REF: SECOND AND FINAL RESPONSE TO CLARIFICATIONS OF THE TENDER FOR SUPPLY, DELIVERY, INSTALLATION, TRAINING, TESTING AND COMMISSIONING OF DOPPLER VERY HIGH FREQUENCY OMNI-RANGE EQUIPMENT AND DISTANCE MEASURING EQUIPMENT (DVOR AND DME) FOR WAJIR AIRPORT: TENDER NUMBER KCAA/015/2024-2025:

**SECOND AND FINAL CLARIFICATIONS SOUGHT BY INTERESTED BIDDERS - DVOR-DME FOR WAJIR
TENDER NO. KCAA-015-2024-25 (14.2.2025).**

DRAWING FOR WAJIR DVOR EARTHING

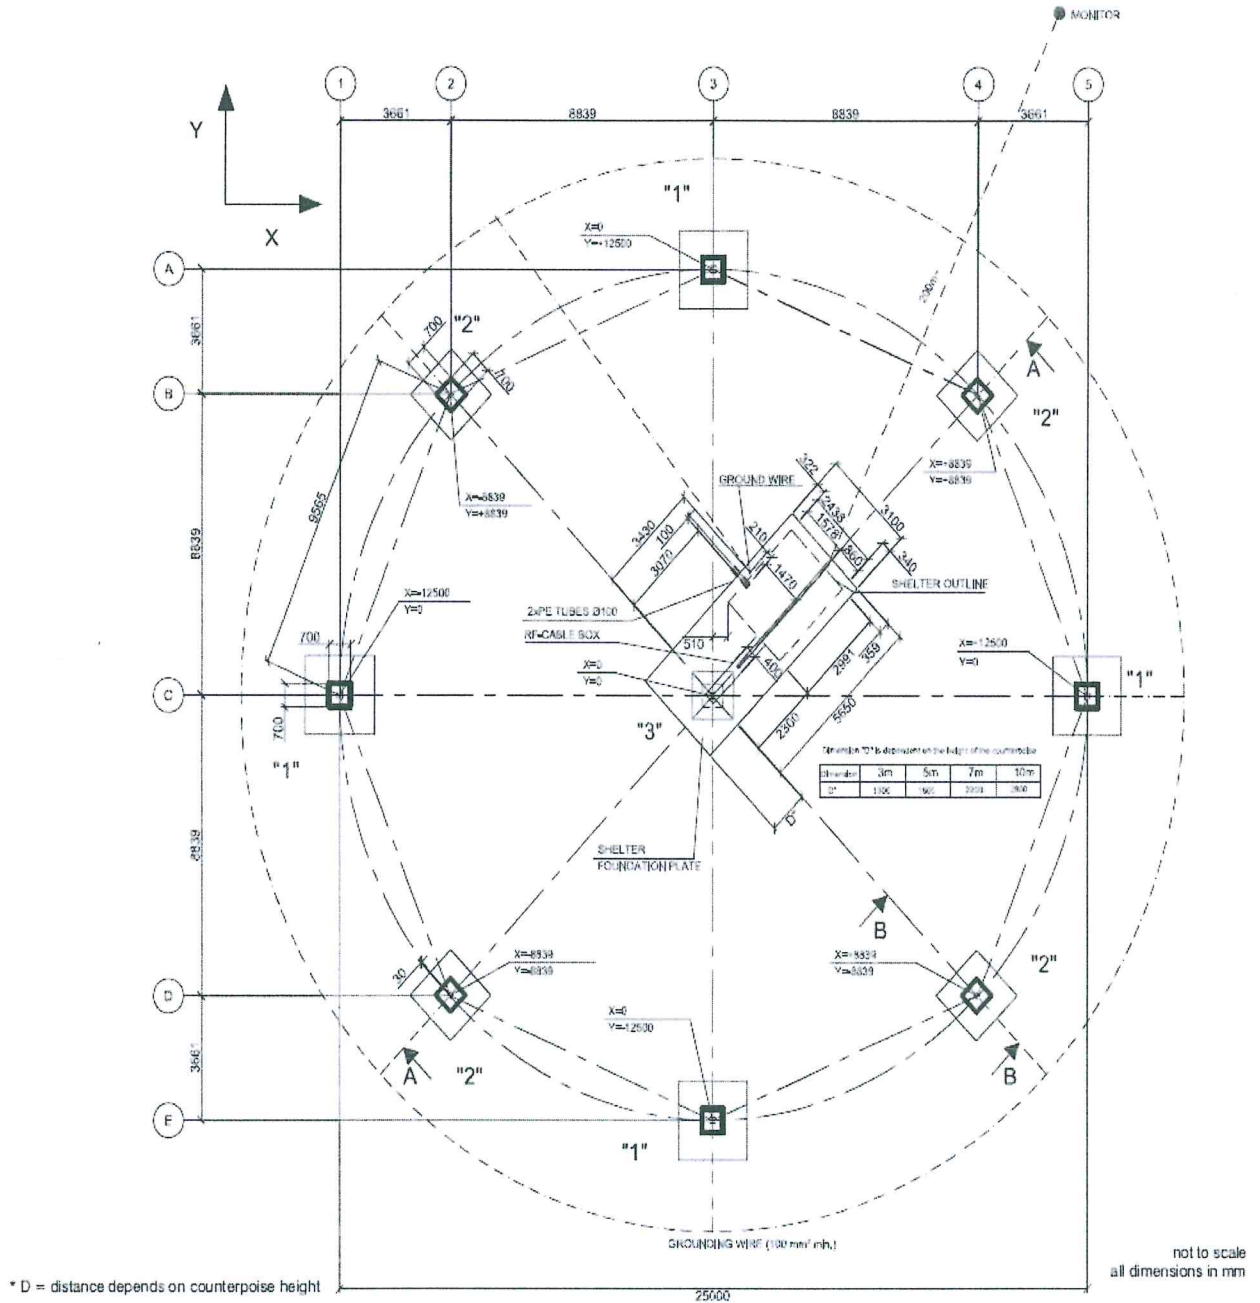
NO.	REQUEST FOR CLARIFICATIONS FROM BIDDERS	KCAA RESPONSES
8.	<p>ix. Counterpoise ✓The bidder to refurbish including painting and re-use of the existing counterpoise ✓Shall ensure the counterpoise is properly earthed</p> <p>ix. Electrical works ✓The bidder to refurbish including painting and re-use of the existing counterpoise Shall ensure the counterpoise is properly earthed</p> <p>QN: Please share the existing earthing drawing of the counterpoise.</p>	<p>A drawing of the existing earthing is herein attached.</p>
